ORIGINATION FORM

Proposed Revisions to a Standard Plans Index
(Please provide all information — Incomplete forms will be returned)

Index Number: 440-002
Sheet Number (s): 1 of 3
Index Title: Underdrain Inspection Box

UNDERDRAIN INSPECTION BOX ASSEMBLY

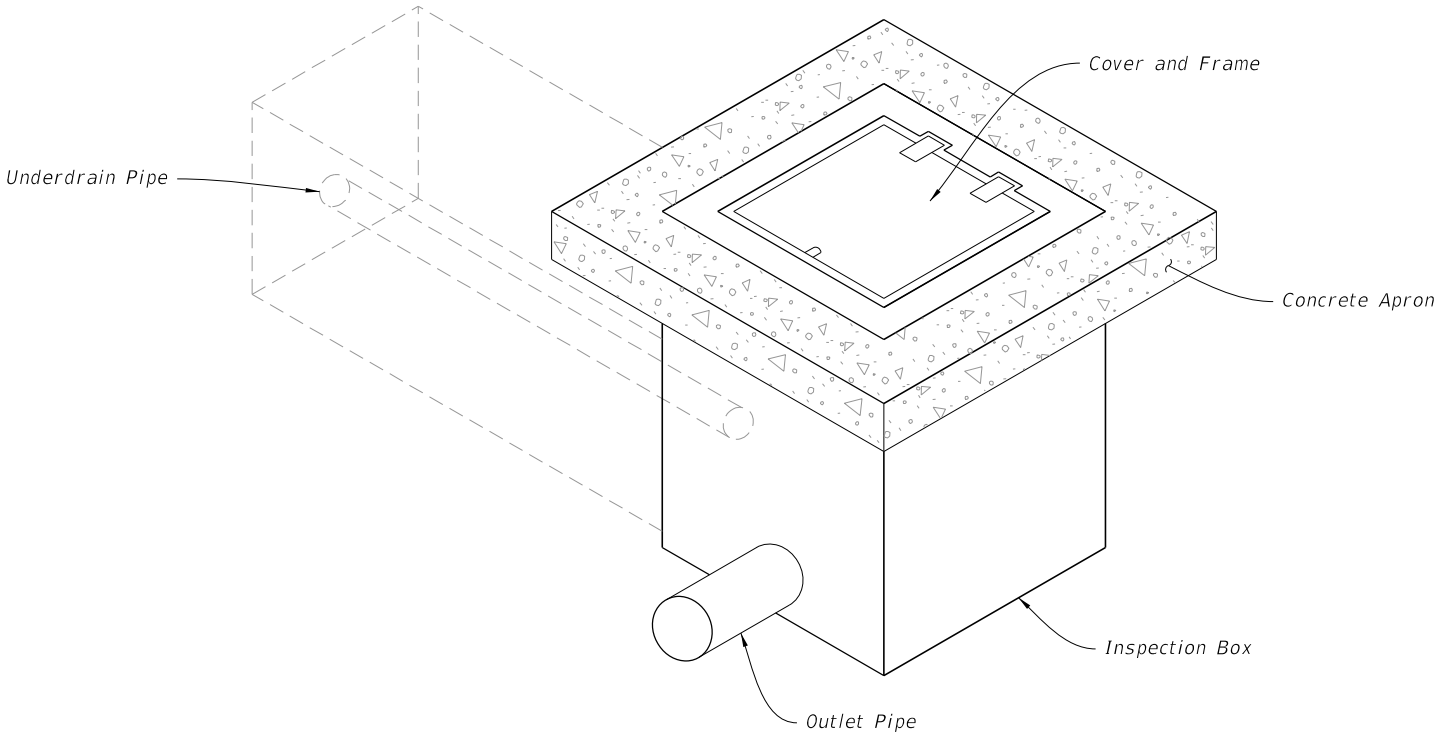
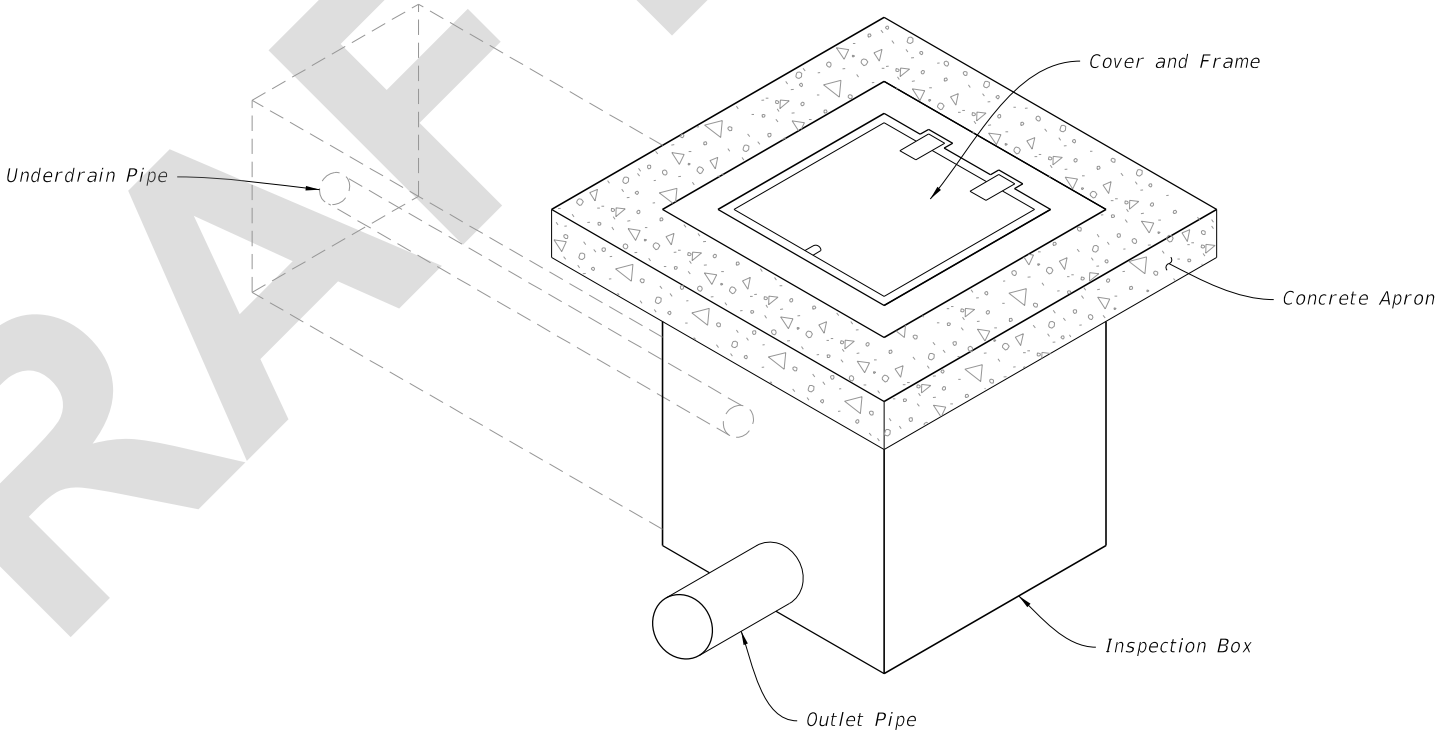
Sheet 1: Changed GENERAL NOTE 2 from "Class I" to "Class II".

Changed to reflect Materials specification change that removes the designation for Class I Concrete.
Please see the attached Standard Specification Section 346 DRAFT for the Class I revisions proposed by the State Materials Office

CHANGED TO: Class II

- 1. Install light duty cast iron cover and frame in accordance with Specification 962.
- 2. Use Class II concrete. Use No. 3 bars (Grade 60) on 8" centers both ways, sides and bottom.
- 3. Furnish covers with pick holes. Do not use fitted lifts or handles.
- 4. Manhole Type P Alternate A, Index 425-010, Type I Frame and Cover, Index 425-001, may be used in lieu of the box detailed in this Index.
